ASSESSMENT REPORT

4 Murray Rose Avenue, Sydney Olympic Park SSD 6076 MOD 2

Figure 3: Approved (top) and proposed (bottom) plant enclosure layout (Source: SSD 6076 MOD 1 and applicant's EIS)

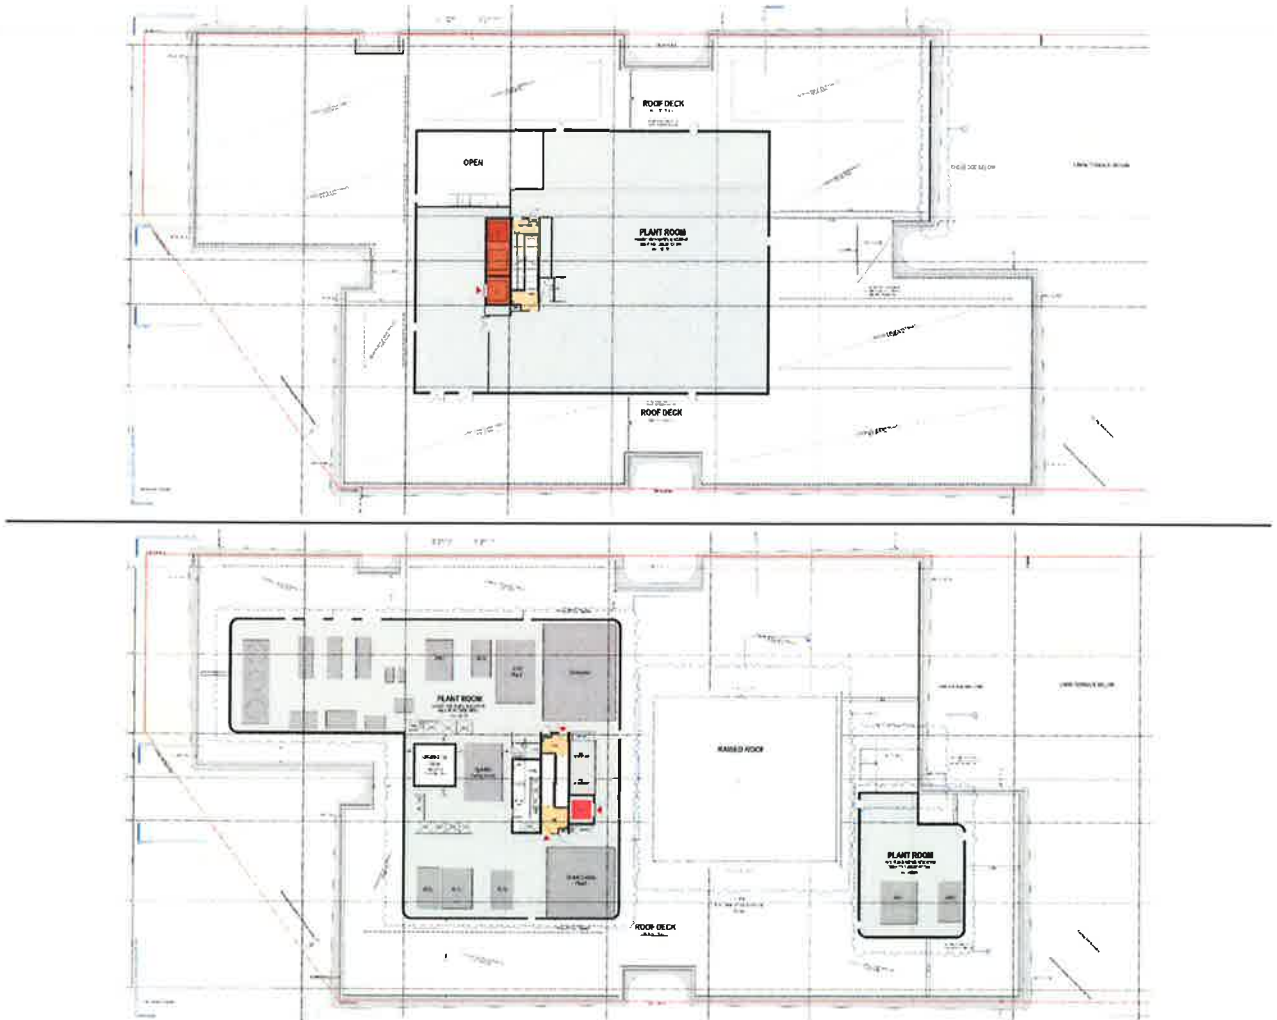
Issue	Consideration	Recommendation
<i>External alterations</i>	<ul style="list-style-type: none"> The proposal seeks approval for external amendments to the eastern, northern and southern facades of the building including new doors, louvres, windows and window façade treatment. In addition, the roof top plant enclosure has been enlarged and a raised roof has been provided above the new central void space (refer to Figures 3 to 5). The applicant states the changes are not significant and generally have a positive impact on the appearance of the building. Furthermore, the roof plant enclosures have been set back from the building edge. The Department considers the changes to the façades of the building are minor in nature and do not alter the overall architectural design or appearance of the building. In addition, the proposed new windows within the eastern elevation will provide further ground floor level activation and surveillance (refer to Figure 4). The Department considers that the enlargement of the roof top plant enclosure (creating two separate enclosures) would not increase the overall visual bulk of the building, noting that the approved plant enclosure is already a substantial structure. Furthermore, the proposed enclosures would be set back from the parapet edge of the building, which ensures the plant will be a visually recessive component of the overall building design. Due to the low height of the raised roof, it would not be visible from the street and is therefore considered acceptable. The Department therefore considers that the proposed external alterations to the building are acceptable and would not have an adverse impact on its design or appearance. 	No additional conditions or amendments necessary.
